Sub Regional RTEP Committee - Western

March 2, 2011

2011 RTEP Baseline Analysis Update

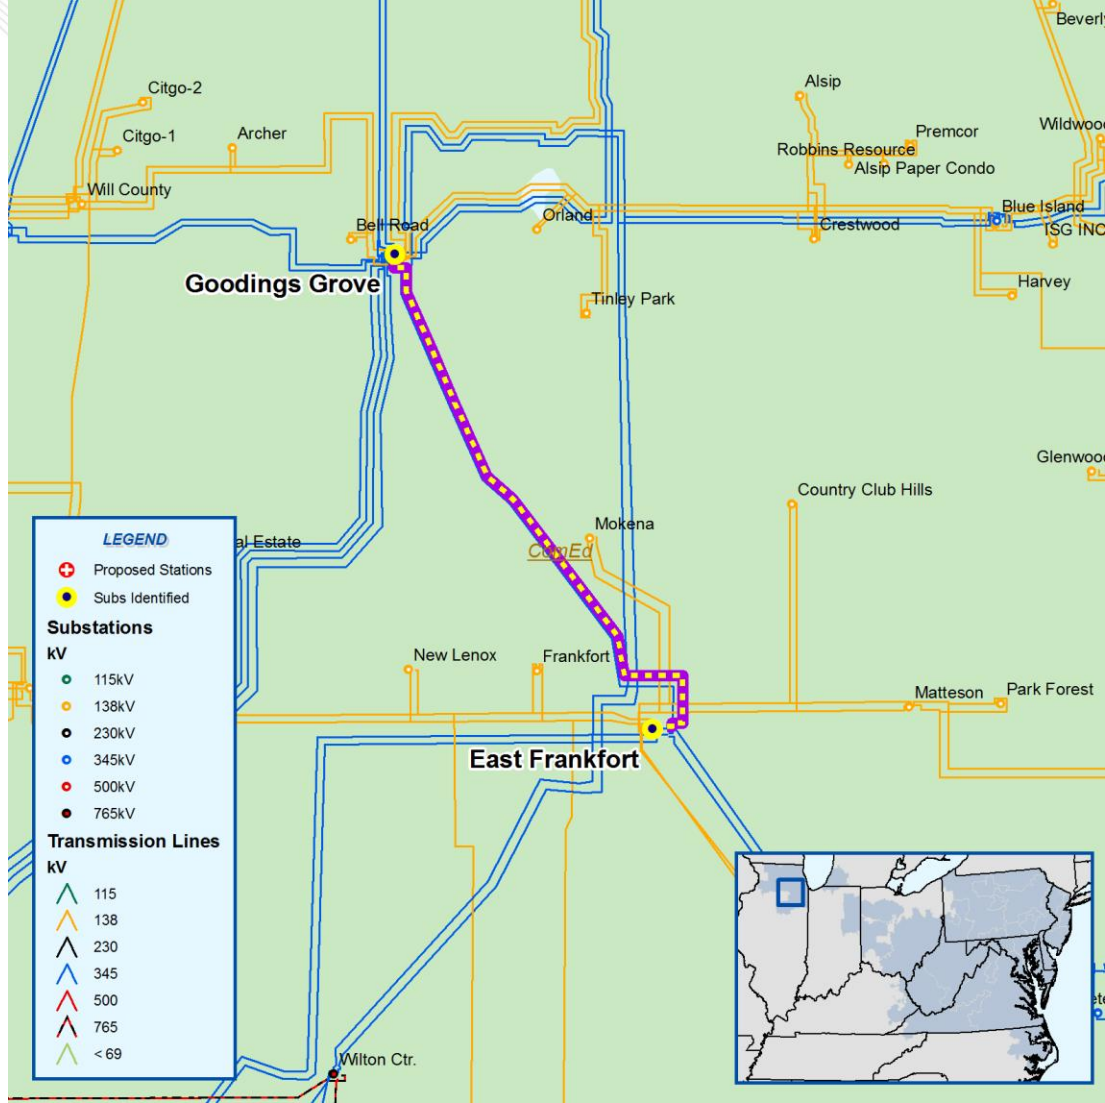
- Baseline upgrades to install a 2nd East Frankfort 345/138 kV autotransformer (B0569.1) and reconductor Country Club Hills – Matteson 138 kV (B0569.2) are replaced with reconductoring the East Frankfort – Goodings Grove 345kV 11601 line (B1300)
- Original Estimated Cost: \$22 M
- New Estimated Cost: \$22 M
- Original Expected IS Date: 6/1/2015
- Updated Expected IS Date: 6/1/2013

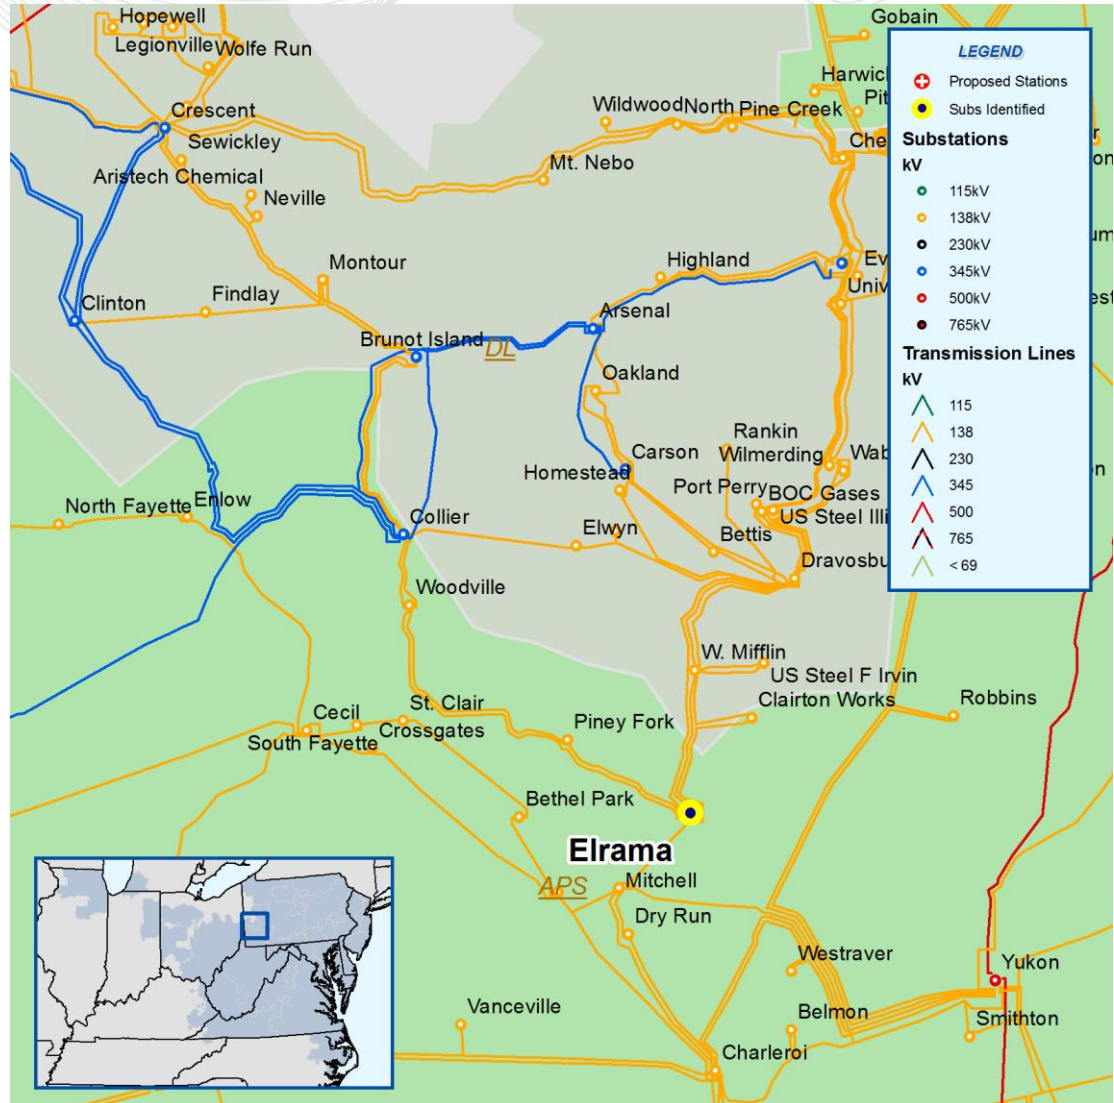
- DLCO plans to retire the 138kV reactor between the Elrama No. 4 and Sync 138kV buses
- The reactor is near end of life and system conditions have changed rendering it ineffective
- The Elrama No. 4 to Sync 138kV bus tie breaker will not be affected and will continue to operate normally closed

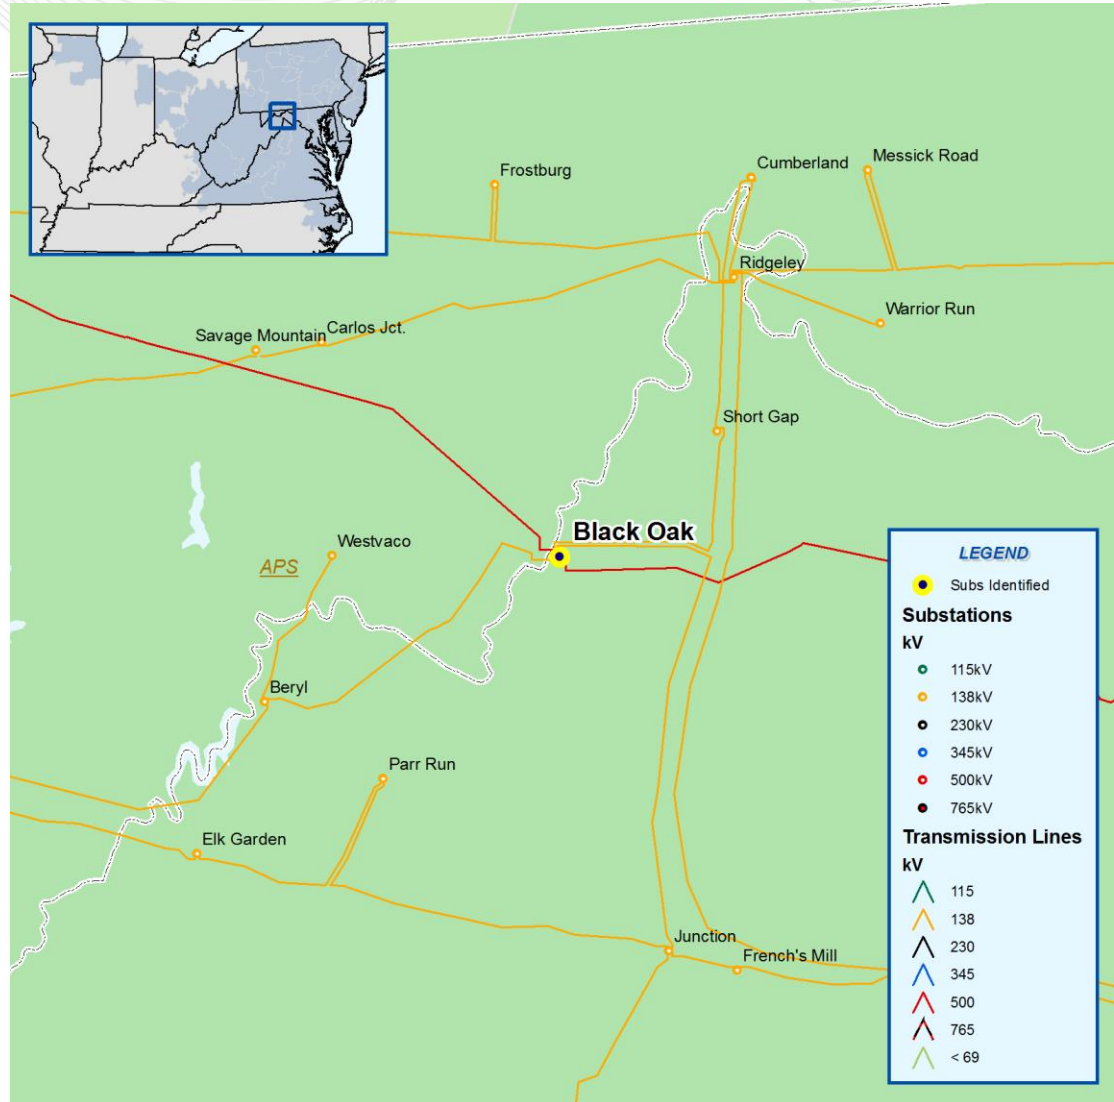
- Update to project b1171.3
- The b1171 project includes installing a new Black Oak 500/138 kV transformer, reconductoring the Albright – Black Oak 138 kV line, and installing six 500 kV breakers at Black Oak.
- The b1171.3 scope will change from six 500 kV breakers at Black Oak to four 500 kV breakers
- Breakers will not be installed on the 500kV side of the Black Oak 500/138 kV transformers

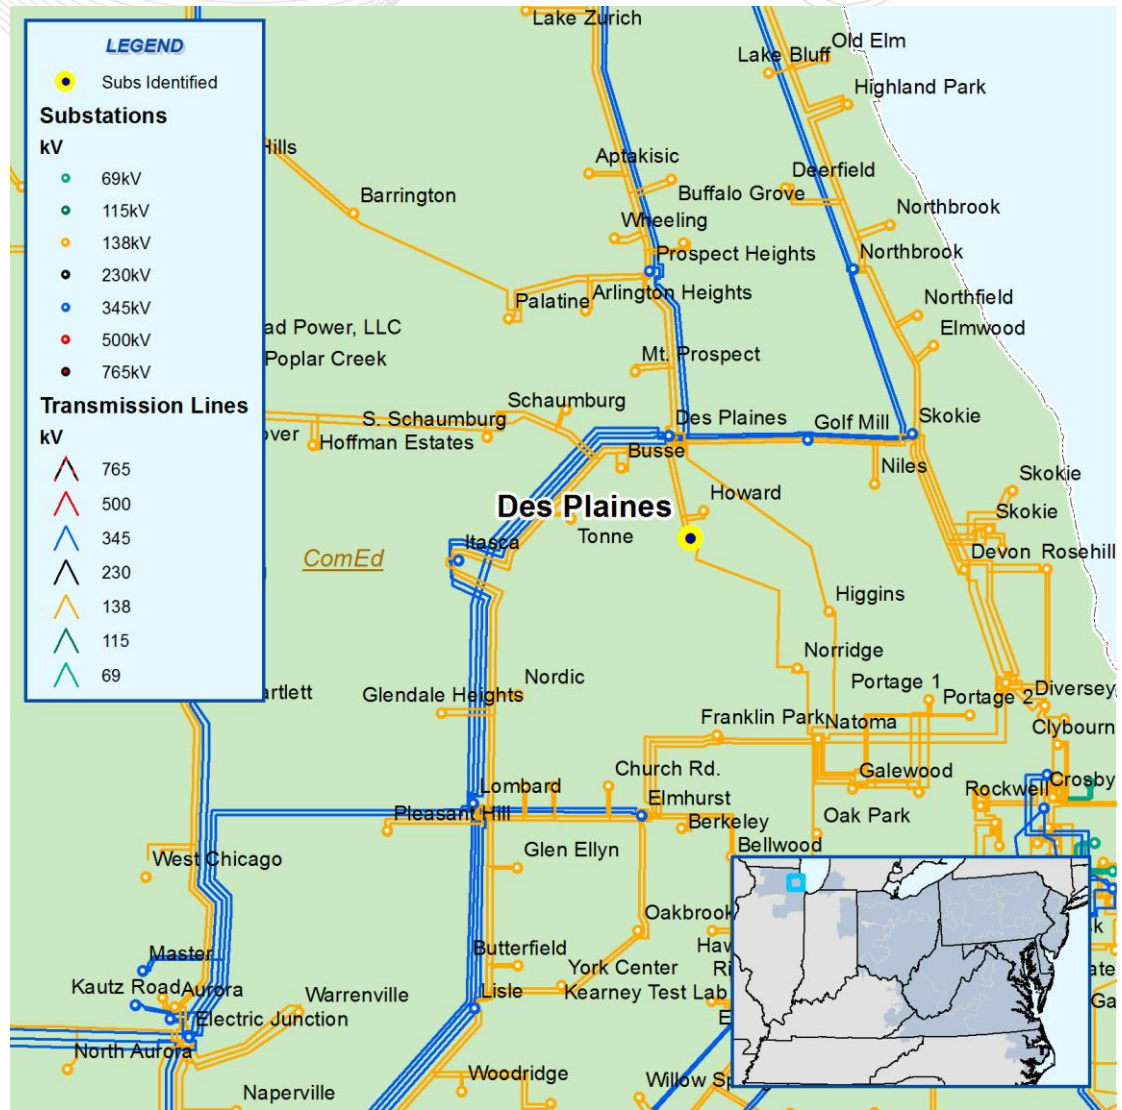
- The Des Plaines 138 kV breaker '46 4610' is overstressed
- Driver: Previous baseline upgrade to normally close 345 kV BT 2-3 at TSS 103 Lisle (b1266)
- Proposed Solution: Revise the reclosing on the DesPlaines 138 kV breaker '46 4610' (b1266.1)
- Estimated Project Cost: \$50 K
- Expected IS Date: 6/1/2015

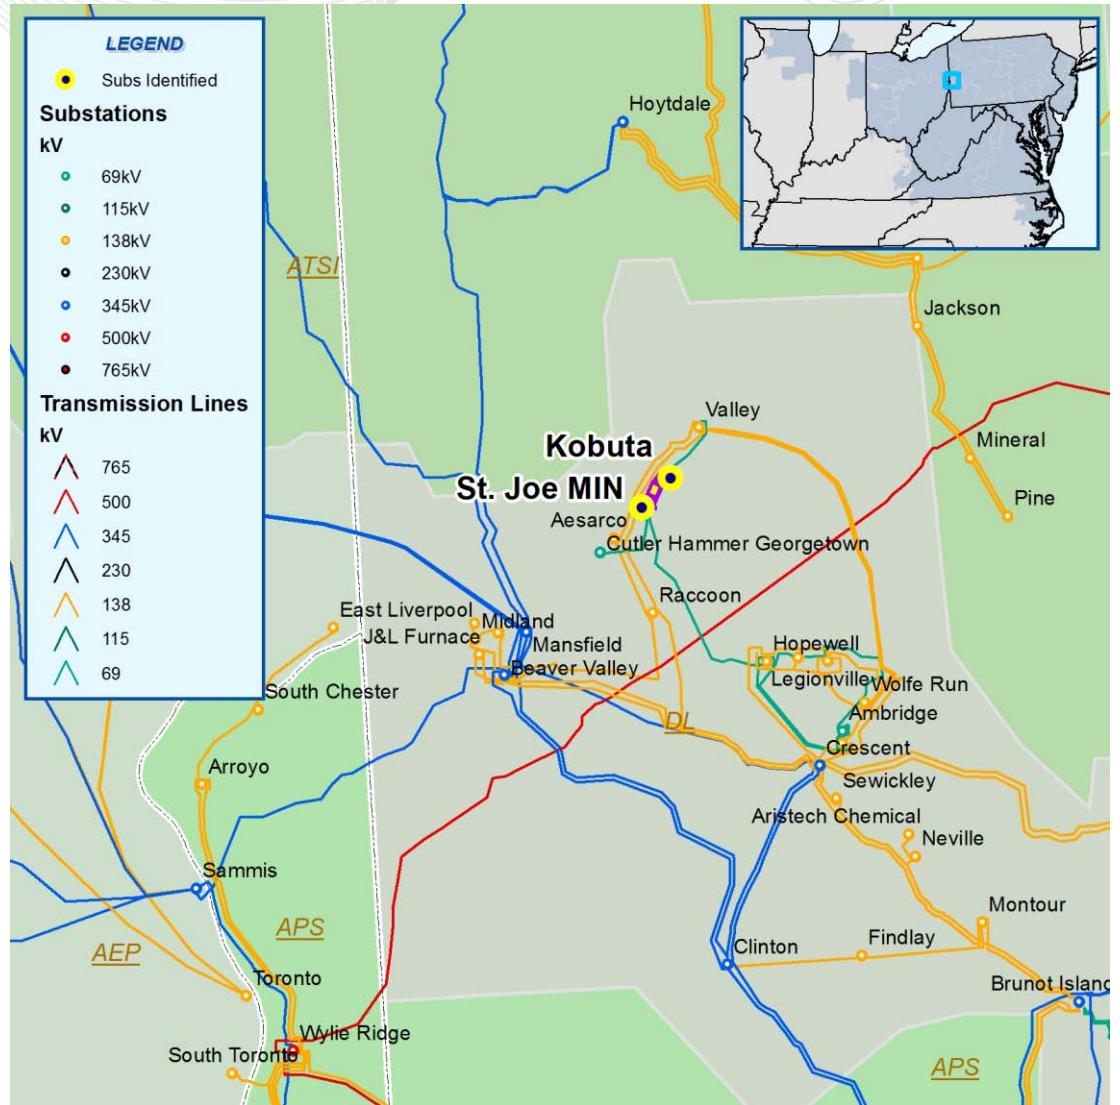
- Driver: Correct abnormal configuration
- Connect the Brentwood substation tap to both sets of bifurcated conductors on the Dravosburg Elwyn (Z-70) 138kV circuit (s0278)
- Cost: \$0.05 M
- IS Date : 12/31/2011
